CITY OF STOCKTON

LETTER OF CLARIFICATION NO. 2

MCKINLEY PARK RENOVATION PROJECT NO. WR21017

SCALE	AS SHOWN	APPROVED BY:	SHEET NO.
DESIGNED BY	DCM	DATE	IR1.1
DRAWN BY	CM		53 OF 156 SHEETS
CHECKED BY	BW	CITY ENGINEER	WR21017
RECORD DWGS.		STOCKTON, CALIFORNIA	PROJECT NO.

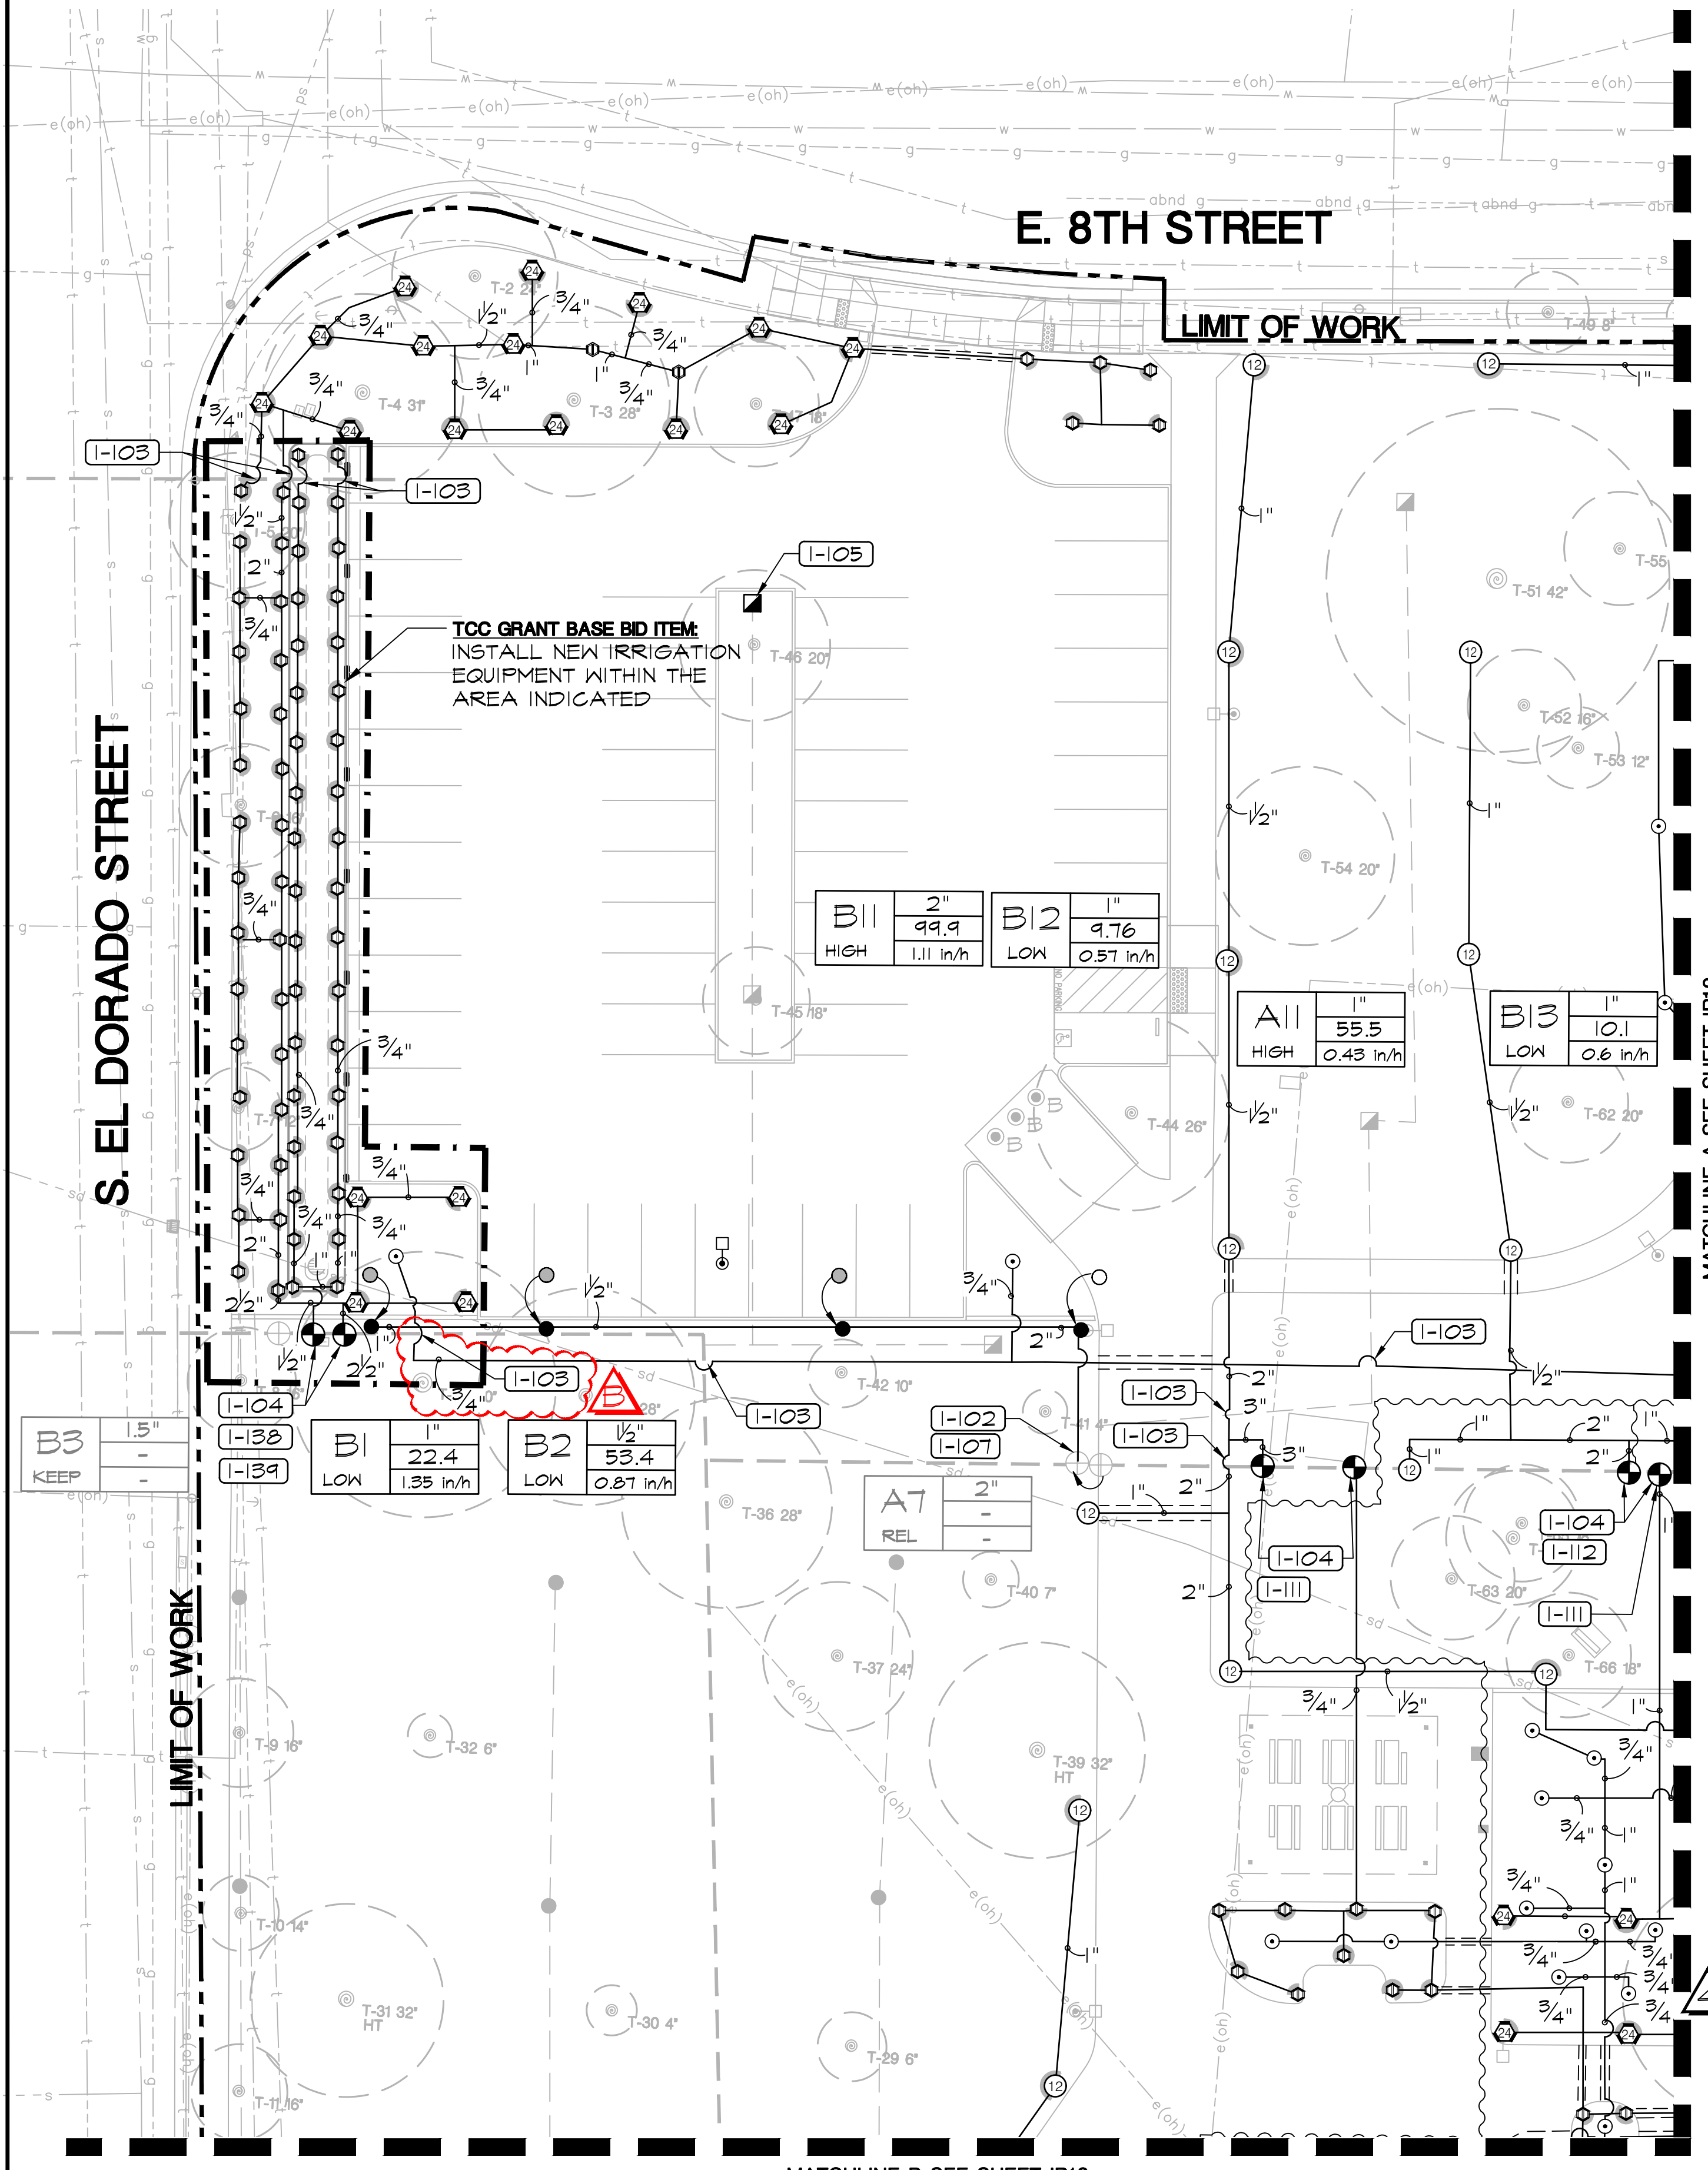
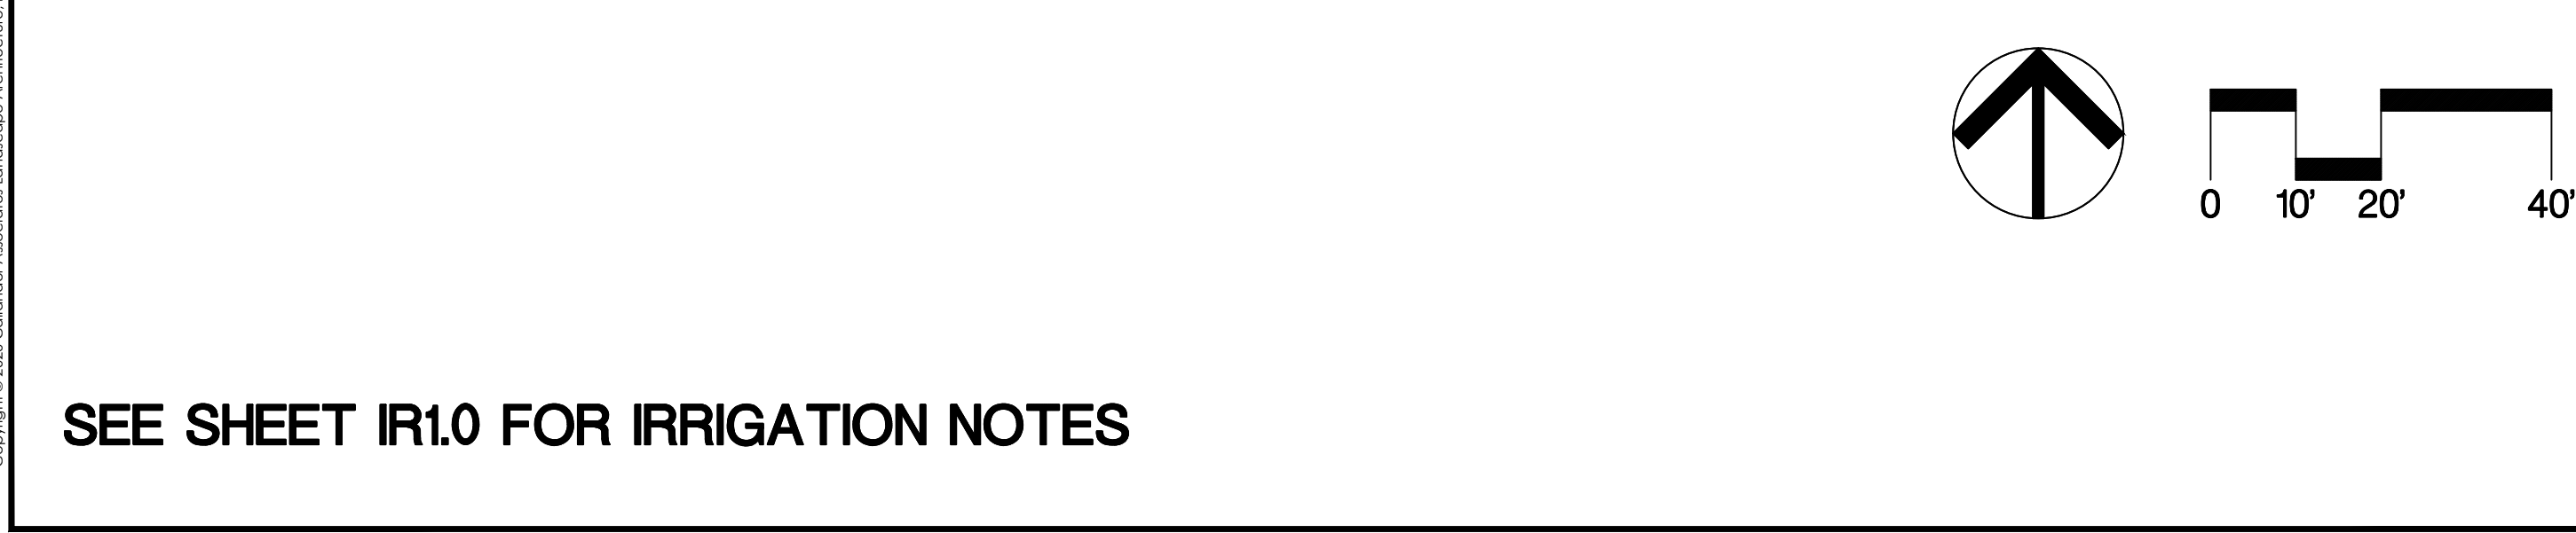
8. Sheet IR 1.1 Keynote I-101

- a. **REVISE** the keynote pointing description to read: **"I-101 I-103"** per attached revised sheet IR1.1.

DEPARTMENT OF PUBLIC WORKS CITY OF STOCKTON, CALIFORNIA	
SCALE AS SHOWN	APPROVED BY: _____ DATE _____ SHEET NO. IR1.3
DESIGNED BY DCM	55 OF 156 SHTS.
DRAWN BY CM	WR21017 PROJECT NO.
CHECKED BY BW	CITY ENGINEER
RECORD DWGS.	STOCKTON, CALIFORNIA

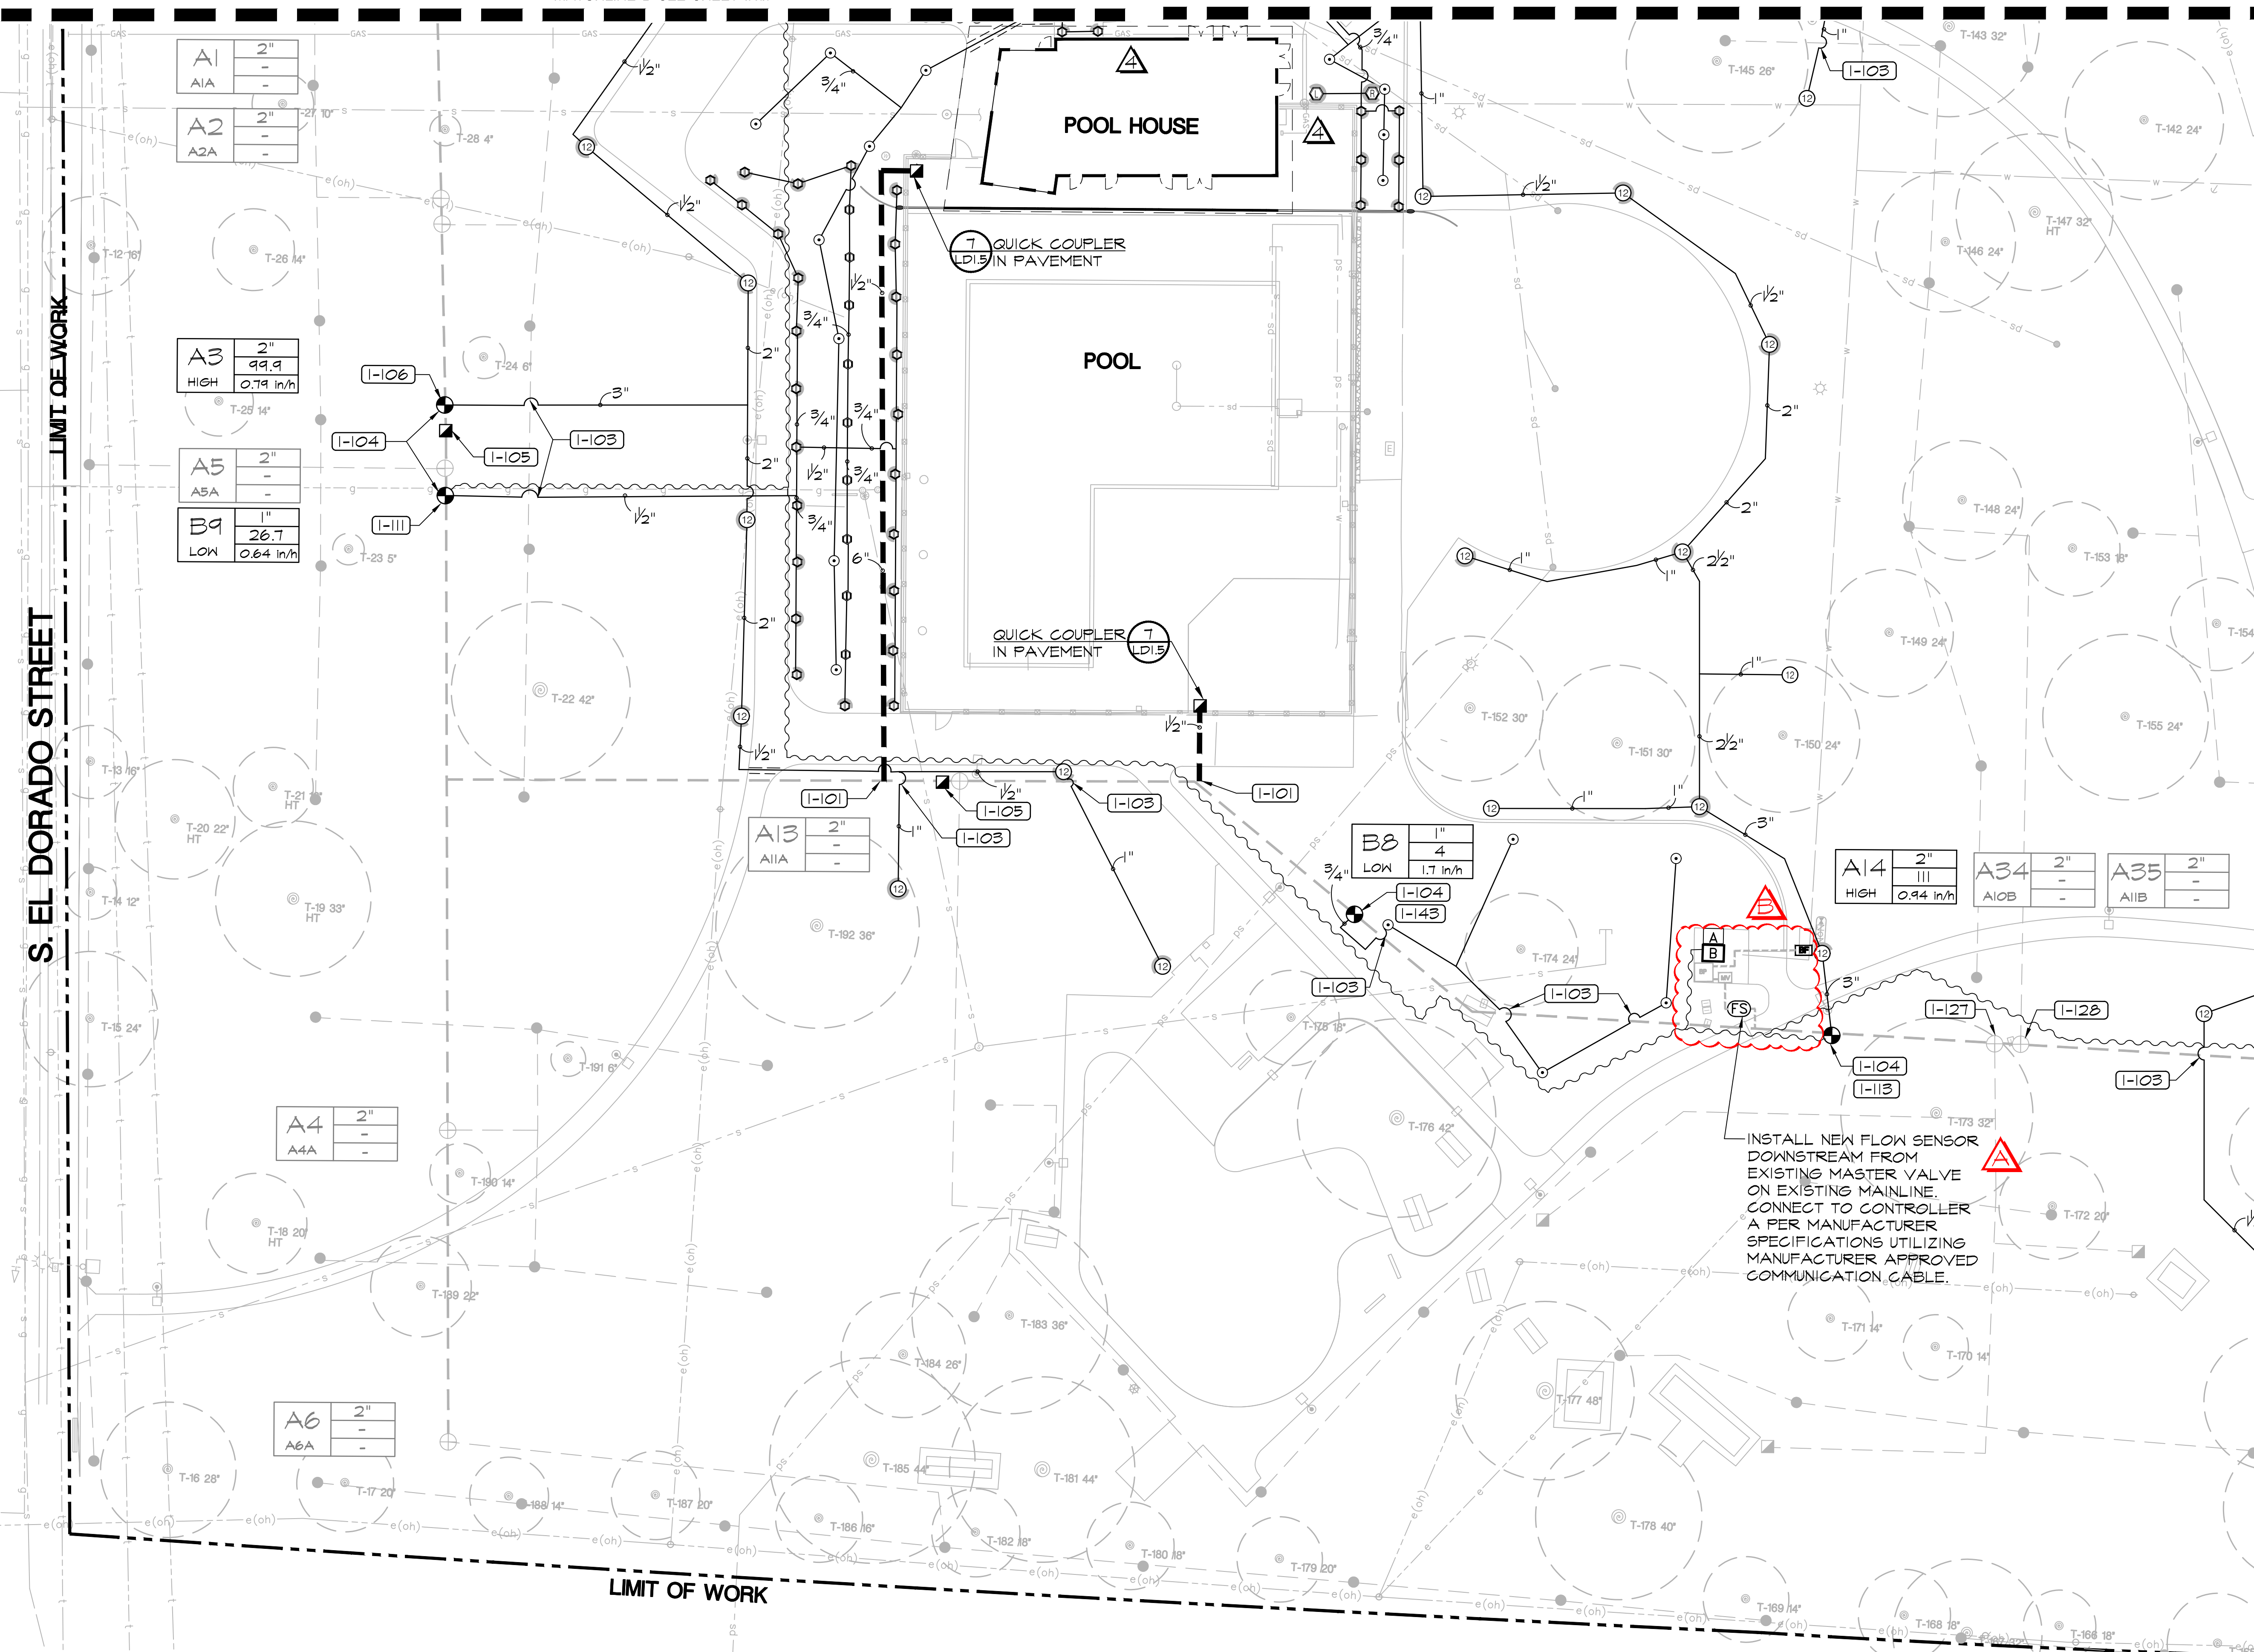
9. Sheet IR1.3 Mainline Pipe from Backflow Preventer to Booster Pump

- a. **REPLACE** with the attached revised Sheet IR1.3, which changes the mainline pipe between existing below ground double check valve and pump building to show as existing 8" pipe.
